Vermont Agency of Transportation
RECEIVED
 CK'D BY JG OK'D BY WL
 April 10, 2014
 RESUBMIT YES Rejected
 BY KH DATE 4-21-2014

Project: PITTSFIELD ER BR F 022
 PITTSFIELD, VT

Drawing: APPROACH SLABS
 Customer: COLD RIVER BRIDGES

Date	Drawn	Chkd.	JOB No.	Dwg. No.
3-7-14	TRH		33505162	R01B

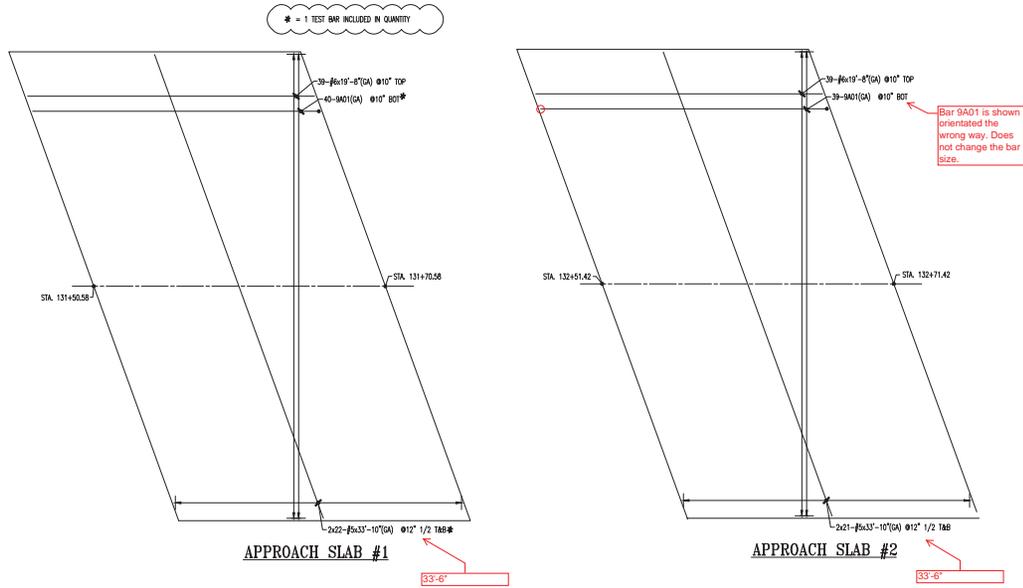
Bar 9A01 is shown orientated the wrong way. Does not change the bar size.

Only 9A01 is for Approach Slab

Please provide Bar level, Grade, and ASTM designation
